LOC2023-0212

Springbank Hill Community is unable to support this Application

LOC2023-0212 requests modification to the ASP map

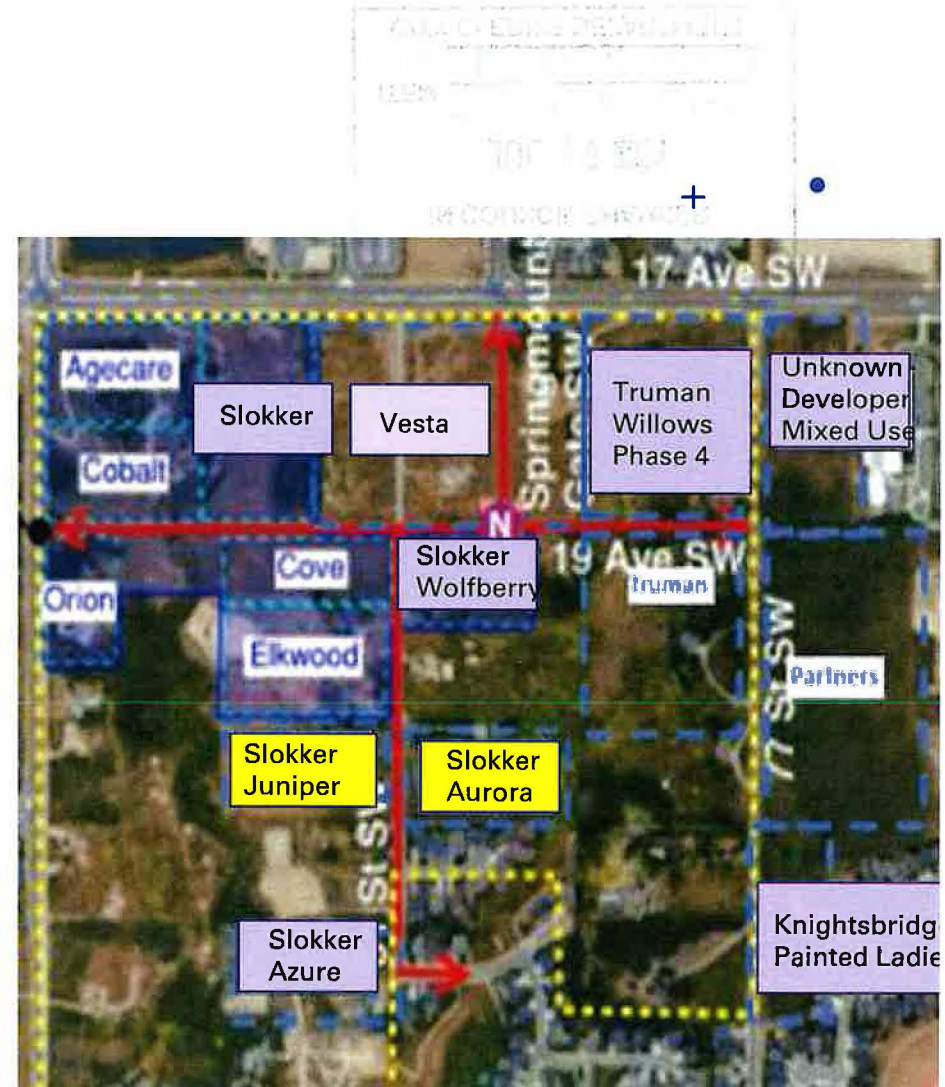
In this version of the Land Use the request specifically is

- Change Low Density Contextual to Low Density
37uph - 85% increase
- Change Low Density to Medium Density
*The developer promises to cap it at 65uph (d65)
65uph – 76% increase

WHAT IS THE JUSTIFICATION ?

LOC2023-0212 TRANSPARENCY

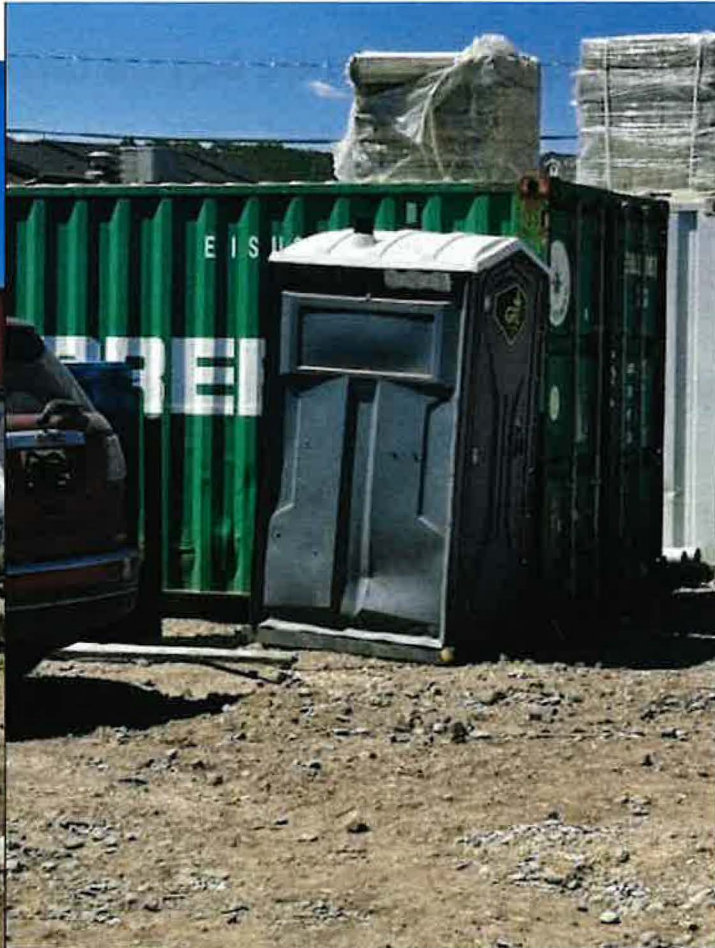
Stripping and Grading

Currently being used for

- **Parking**
- **Haul Trucks**
- **Constuction Storage, Construction Staging, Construction Waste, Construction Offices**
- **Generator**

ER to the East has been damaged

In discussion with Administration all the above has taken place without the proper permitting
